Community Development

RE: Type I Application - Land Development Review - LDR25-0034
Project Proposal: Future Large Lot Subdivision (6-Lots) application
Parcel Number: 0238830000000
Status: **Conditional Approval**

STEP 1 – LAND DEVELOPMENT REVIEW STATUS: CONDITIONAL APPROVAL

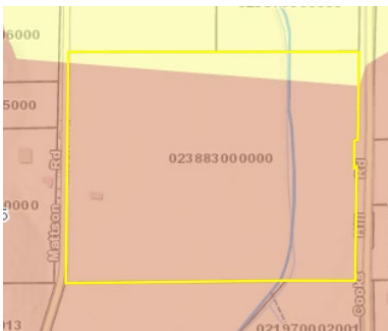
- Wetland Report reviewing the entire parcel and each individual proposed lot; the new wetland report shall meet the current Lewis County Code 17.38 – note: the wetland report from 2016 on this parcel does not meet the current code criteria for Lewis County Code 17.38 and is not for the entire site, nor for the proposed lots;
- Stream & Habitat Assessment meeting current Lewis County Code 17.38;
- Erosion Hazard and Soil Liquefaction Report (Geo-Technical Study) meeting current Lewis County Code 17.38;
- Identification of 2007 Flood Inundation Area;
- Identification of Flood Zone A (100-year floodplain) boundary from the current FIRM map
